SERVICE BULLETIN

APPLICABILITY 92-94 MY LEGACY

SUBJECT: CLICKING NOISE FROM THE HEATER MODE DOOR ACTUATOR

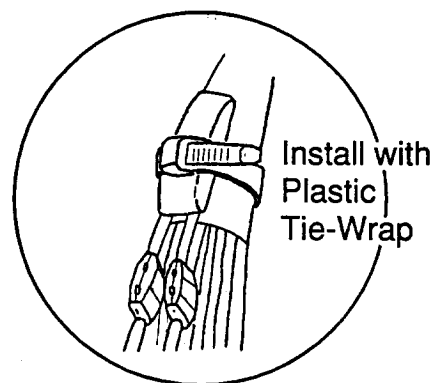
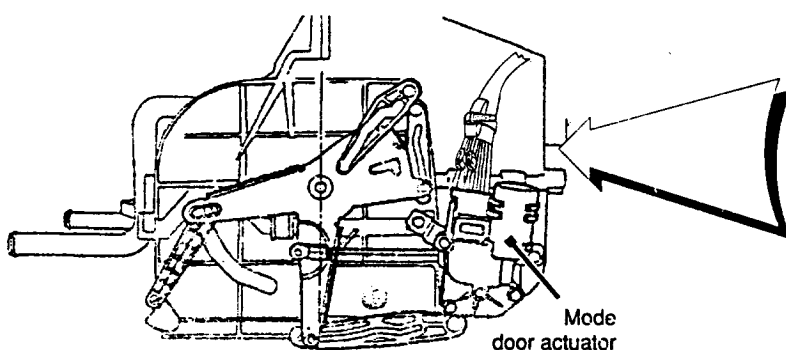
This noise occurs because the actuator will over travel the electrical contacts in the motor housing causing it to reverse its direction. It will keep cycling back and forth until it stops on the contact.

This condition is caused by one or both of the following:

- (A) Loose, worn-out, or misadjusted linkage.
- (B) The door actuator motor torque is on the upper limits of the specifications.

To correct this condition you must first check and repair as necessary all the linkage for looseness and verify that the mode door actuator control rod adjustment is correct. This adjustment can be found in the 1992 service manual section 4-6 page 23. If the linkage is tight and adjusted correctly use the following procedures to correct the condition.

- (1) Disconnect the negative battery cable.
- (2) Remove the lower instrument panel cover below the steering column.
- (3) Locate the mode door actuator wiring harness and find the white with a blue tracer and blue with a black tracer wires going to connector B-89 at the motor. Install the resistor assembly (part number 72081AA260) to these wires using the tap-in connectors and secure them with electrical tape.
- (4) Using a plastic tie-wrap secure the resistor assembly to the harness.
- (5) Check for normal operation of the mode door actuator and reinstall the lower panel.
